**Environmental  
Planning  
Commission**

**Agenda Number: 03  
Project Number: 1005455  
Case Number: 18EPC- 40015  
Hearing Date: May 10, 2018**

**Staff Report**

<b>Agent</b>	Arch & Plan Land Use Consultants
<b>Applicant</b>	Robert Gutierrez Investment Co. LLC
<b>Request</b>	<b>Site Development Plan for Subdivision</b>
<b>Legal Description</b>	All or a portion of Lot B, El Jaral
<b>Location</b>	West side of Montoya Rd. NW between Interstate-40 and Maximillian Rd. NW
<b>Size</b>	Approximately 4.5 acres
<b>Existing Zoning</b>	SU-1 for RA-1/PDA (Planned Development Area)
<b>Proposed Zoning</b>	N/A

SITE PLAN REDUCTIONS

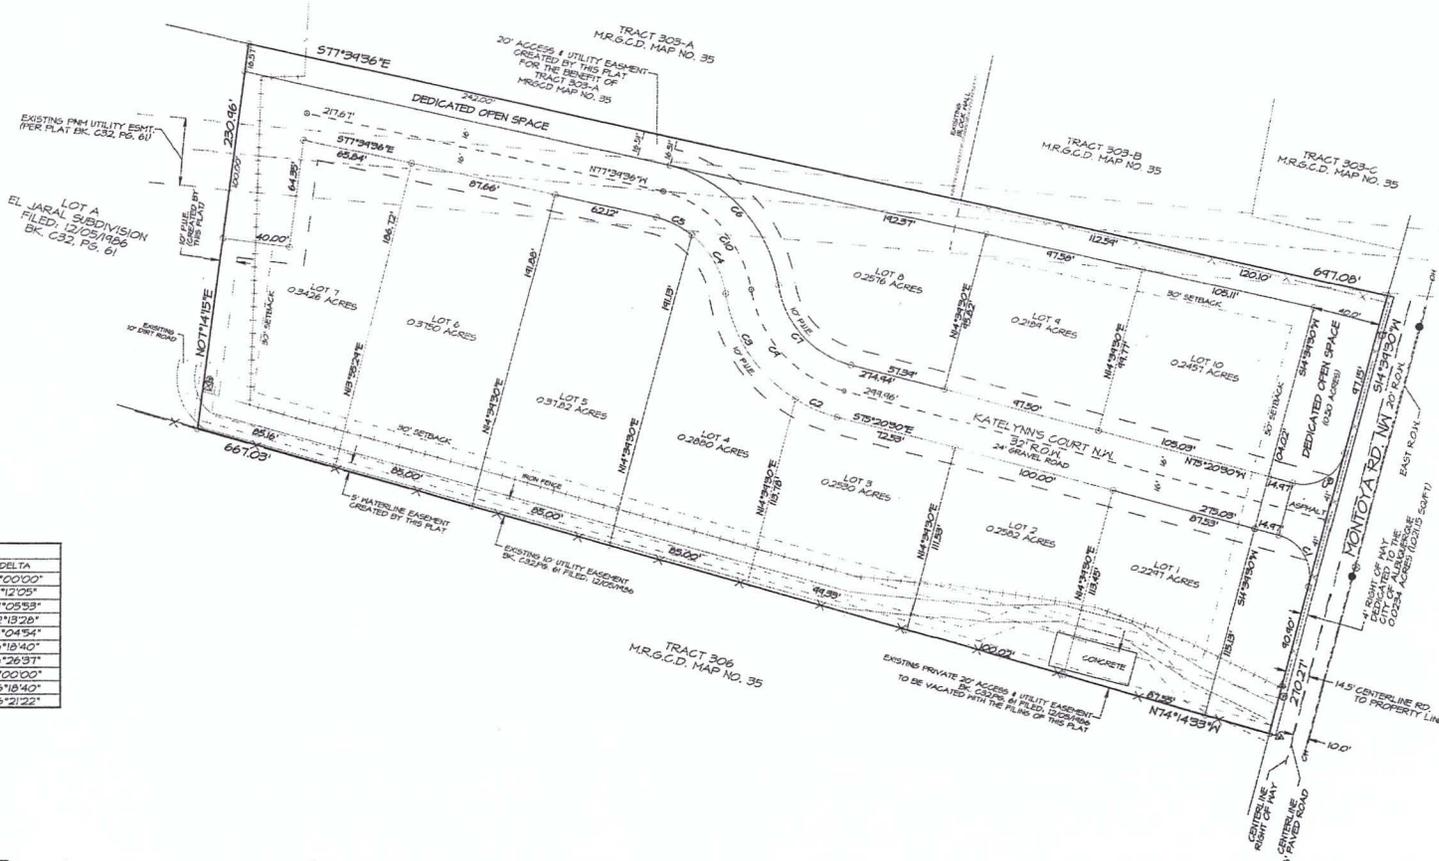
- Need complete detailed site plan with all entrances/exits and dimensions clearly indicated, including the mentioned (#5) circular turn around. To verify safe refuse truck access/exit.

The Open Space Division would like to clarify that the land designated as “Dedicated Open Space” is privately owned and managed and will not be conveyed to City Open Space without prior Open Space Division approval.

Need complete detailed site plan with all entrances/exits and dimensions clearly indicated, including the mentioned (#5) circular turn around. To verify safe refuse truck access/exit.

2. Prior to application submittal to the DRB, the applicant shall meet with the staff planner to ensure that all conditions of approval are met.
3. Per the annexation agreement, Site Access #5 (p4), “A circular turn around must be provided at the end of the private road.” The applicant shall provide a turn-around interior to the site that is acceptable to the City Fire Marshall’s office.

4. The applicant shall provide a Landscape Plan that shows landscaping, including existing trees and proposed trees as required by the annexation agreement.
